Greater London Industrial Archaeology Society

18 Nov 2014

**Provender Store, Stables Market, Chalk Farm Road, London NW1 8AH,
Application Nos. 2014/6272/P and 2014/6589/L**

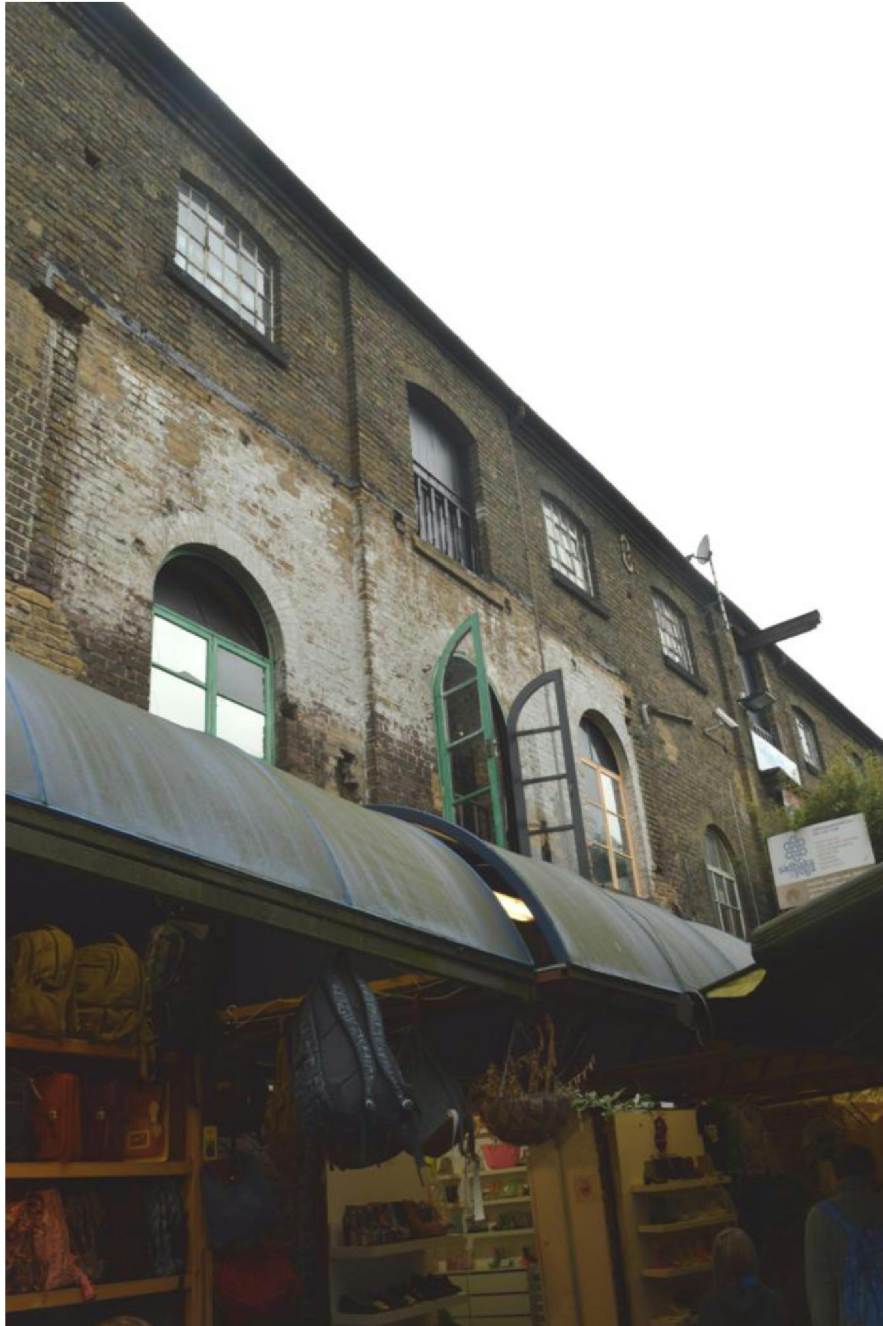
Section 1, north end, 29 Nov 1975 (MTT595_6A), showing former bridge to Tack Room

Section 1, north end today
